# UNITED STATES PATENT AND TRADEMARK OFFICE

10/765,470

# Office Action Summary

## **DETAILED ACTION**

Fig. 2

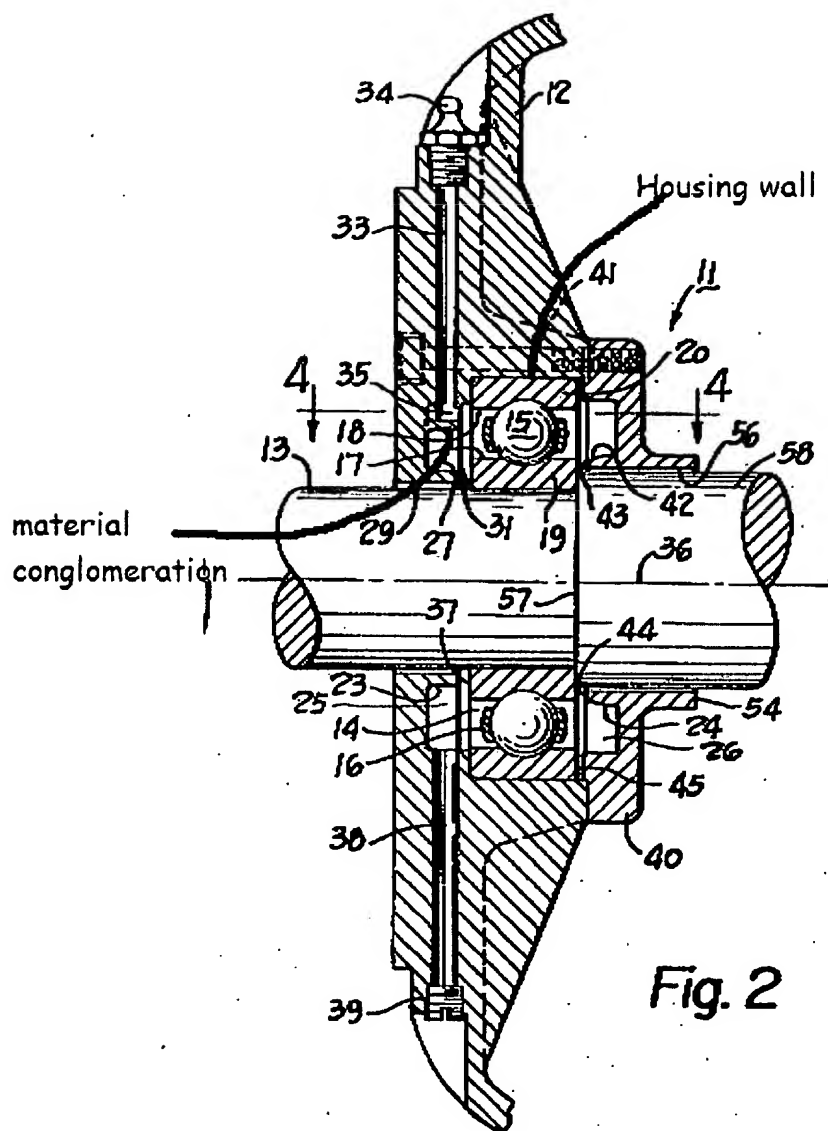
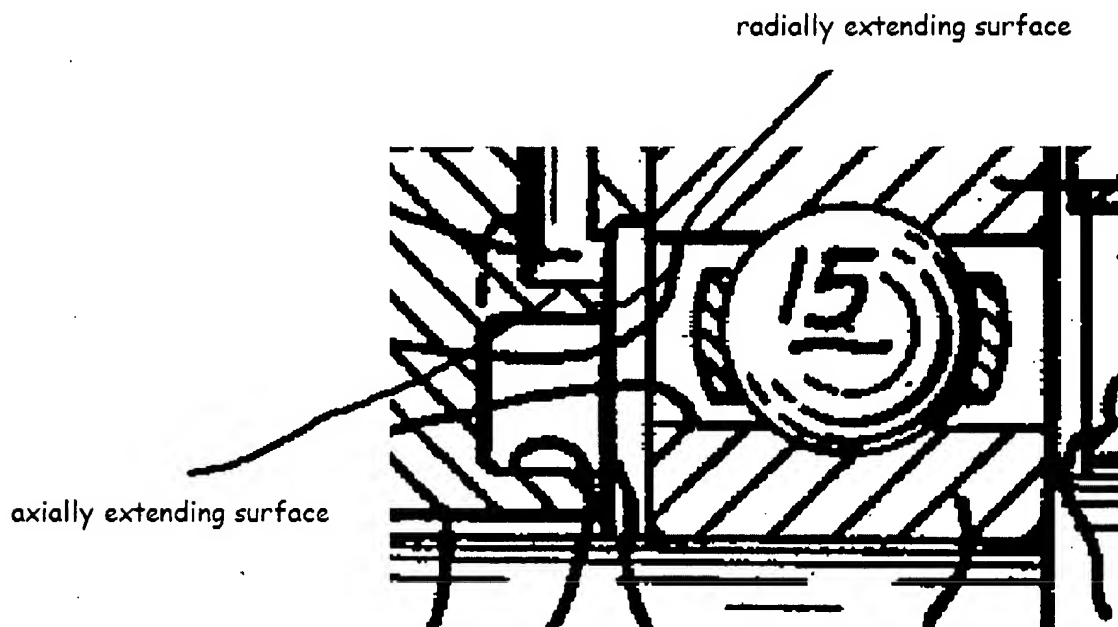
Simmons discloses a grease lubricated bearing housing (12) possessing an interior and having a housing wall (see figure below) arranged to form a bearing seat for an outer race ring of a bearing, and having on each axial side of the bearing seat a space (25 and 26) limited by an axially extending wall portion and a radial gable wall, the bearing housing having an opening (29) for receiving a shaft supported in the bearing, the wall of the bearing housing being provided with a through bore (35) adapted to receive a grease nipple and opening to the interior of the bearing housing in at least one of the two spaces axially outside the bearing seat, an interior of the bearing housing wall being provided with a material conglomeration (see fig below) positioned in relative to the through bore opening into the interior of the bearing housing so that the material conglomeration urges grease introduced through the through bore to move primarily towards the bearing seat to inhibit grease from primarily filling out the space into which the through bore opens.

Regarding claim 2, the through bore has an orifice extending through at least part of the material conglomeration, projecting towards the bearing seat.

Regarding claim 3, the material conglomeration possesses a stepped portion comprised of an axially extending surface and an adjoining radially extending surface,

the radially extending surface facing the bearing seat, and the through bore extending through the material conglomeration and opening in the axially extending surface, with the radially extending surface of the stepped portion in combination with the axially extending surface forming a shield urging grease introduced through the through bore to move primarily towards the bearing seat while also preventing grease from primarily filling out the space into which the through bore opens.

Fig. 2

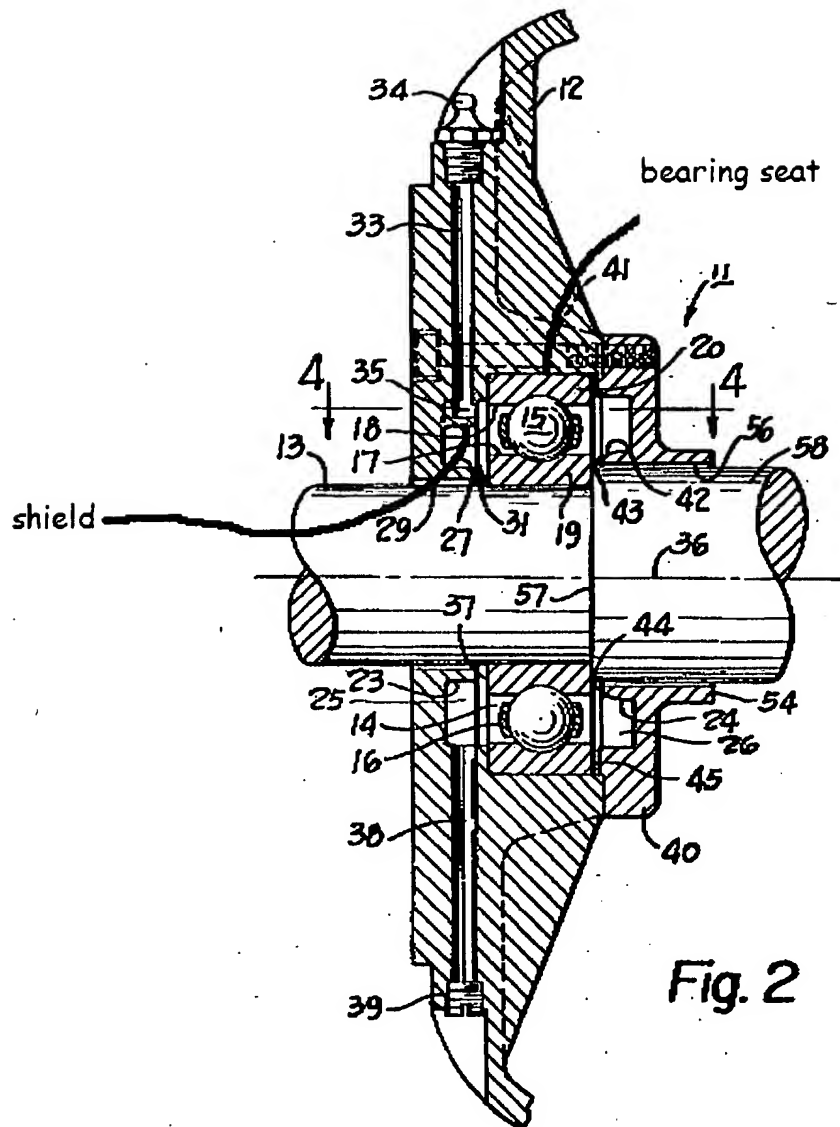
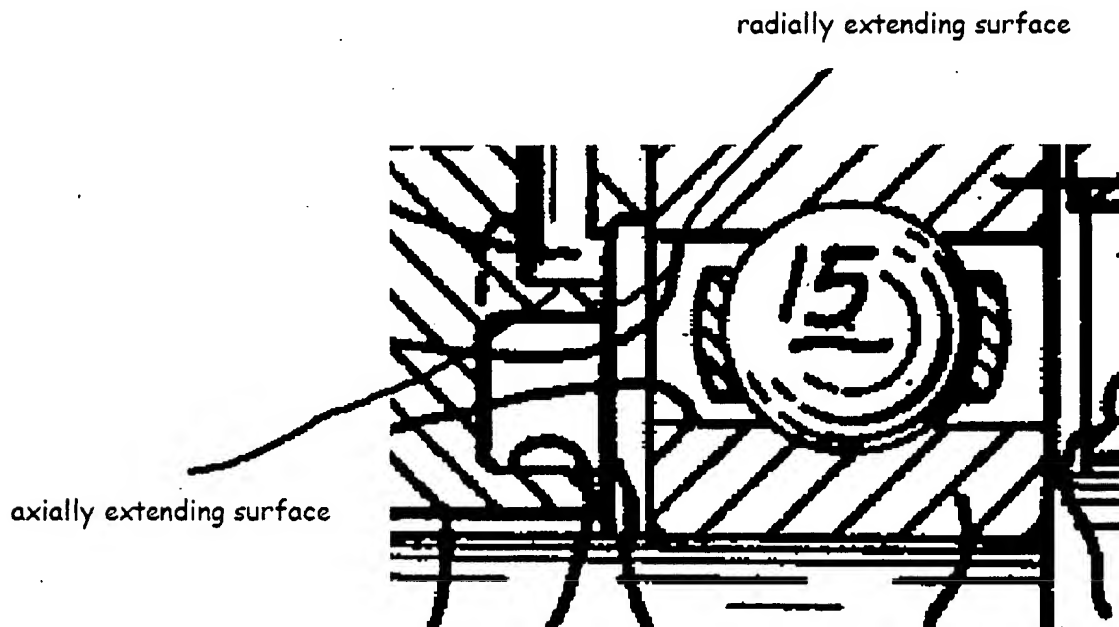
Regarding claim 13, Simmons discloses a grease lubricated bearing housing comprising two housing parts (12, 40) which together form a housing interior provided with a bearing seat in which is seated an outer race ring of a bearing, with an annular chamber (25 or 26) located on at least one axial side of the bearing seat, the space being limited by an axially extending wall portion and a radial gable wall, the bearing housing having an opening at least at one end for receiving a shaft passing at least partially through the bearing housing, a first one of the housing parts being provided with a bore (35) extending from exterior of the bearing housing and opening into the space at a position axially outside the bearing seat, the bore being adapted to receive a grease nipple (34) to permit grease to be introduced into the housing interior, the first housing part having an interior provided with a shield (see figure below) which directs grease introduced through the bore in a direction towards the bearing seat while also inhibiting grease from primarily filling out the space into which the bore opens.

Regarding claim 14, the shield is integrally formed in one piece with the first housing part (12) and the bore extends through part of the shield.

Regarding claim 16, the shield possesses a stepped configuration comprised of an axially extending surface and an adjoining radially extending surface, the radially extending surface facing the bearing seat and the bore extending through the shield and opening in the axially extending surface.
